March 13, 2006  
LIC-06-0021

**SUBJECT: Response to Request for Additional Information Related to Extension Date for Corrective Actions Regarding Generic Letter 2004-02, "Potential Impact of Debris Blockage on Emergency Recirculation During Design Basis Accidents at Pressurized-Water Reactors"**

Attachment 1 -      Response to Request for Additional Information Related to Extension  
Date for Corrective Actions Regarding Generic Letter 2004-02, "Potential  
Impact of Debris Blockage on Emergency Recirculation During Design  
Basis Accidents at Pressurized-Water Reactors"

Figure 1

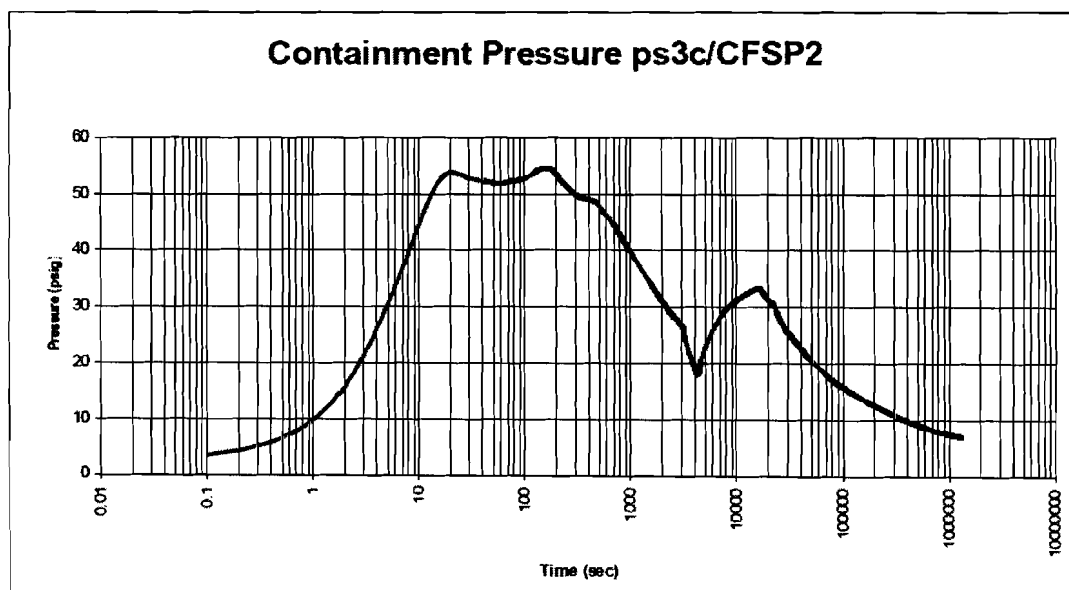
What are the physical stresses on the containment building as a result of the higher water levels using this approach?

The analysis discussed in Section 5.1.B.4.e of EA-FC-04-010, Revision 1, conservatively assumed constant post Recirculation Actuation Signal (RAS) pressure of 40 psig and showed acceptable physical stress on containment. Recently, OPPD has completed a re-analysis of the long-term containment pressure analysis in preparation for the replacement of the steam generators and pressurizer in the fall of 2006. This analysis reflects the larger steam generator and pressurizer water volumes of the replacement components. The following figure shows the results of this analysis:
